RECEIPT DATE: 12/15/20 **ONSITE SEWAGE DISPOSAL SYSTEM** P 572893 -A  
 APPROVAL DATE: 01/15/2021 **PERMIT: CONSTRUCTION** A \_\_\_\_\_  
 PROPERTY ADDRESS: 14556 Old Frederick Road  
 SUBDIVISION: Quartz Hill III LOT: 6 TAX ID: 04-370405  
 CONTRACTOR: WTC CONTRACTORS, INC. EMAIL: \_\_\_\_\_  
 CONTRACTOR ADDRESS: 3033 SALEM BOTTOM ROAD, WESTMINSTER, MD 21157 PHONE: (410)875-9771  
 PROPERTY OWNER: CATONSVILLE BUILDERS, LLC EMAIL: pwalter@catonsvillehomes.com  
 OWNER ADDRESS: 11175 STRATFIELD COURT, MARRIOTTSVILLE, MD 21104 PHONE: (410)442-2215  
 SEPTIC TANK SIZE (GALLONS): 1500 TANK MANUFACTURER: TBD  
 PUMP MODEL: NA PUMP SIZE NA PUMP TANK CAPACITY: NA

**WALL CHECK DRAWING**  
 LOT 6  
**QUARTZ HILL III**  
 PLAT No. 22814  
 1456 OLD FREDERICK ROAD  
 FOURTH ELECTION DISTRICT  
 HOWARD COUNTY, MARYLAND  
 SCALE: 1" = 60' OCTOBER, 2020

**From:** Bricker, Robert  
**Sent:** Wednesday, July 29, 2020 8:53 AM  
**To:** 'ron@vanmar.com'  
**Subject:** Quartz Hill III\_Lot 6\_OSDS Design Plan comment  
**Attachments:** Quartz Hill III-Lot 6\_Septic tank location.pdf

Quartz Hill  
 Lot 6  
 Tank location

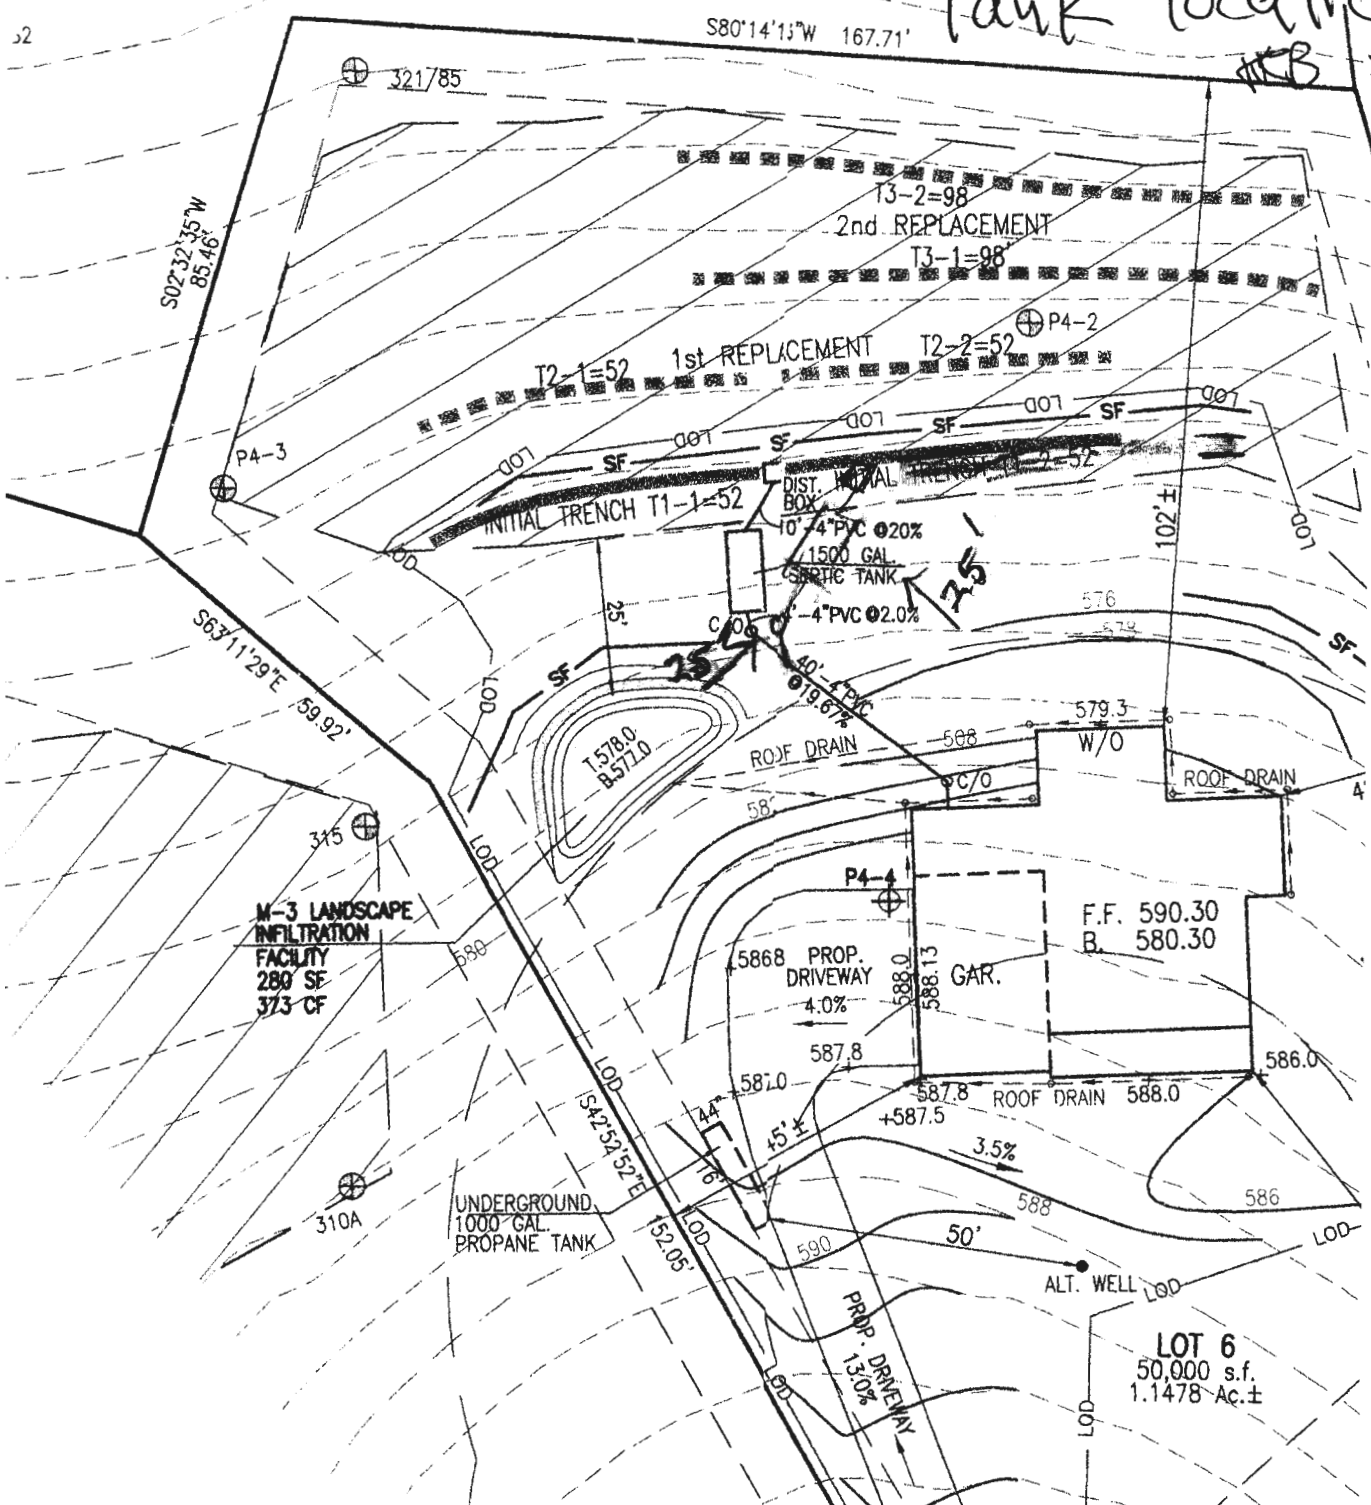
Ron,  
Attached graphic indicates setbacks to septic tank from SWM and slope greater than 25 percent. In addition to the tank moving, it appears that one, or both, of the trenches will be shifted. A little longer run into the tank at 2 percent would be good, too  
Robert Bricker, REHS/RS, L.E.H.S.
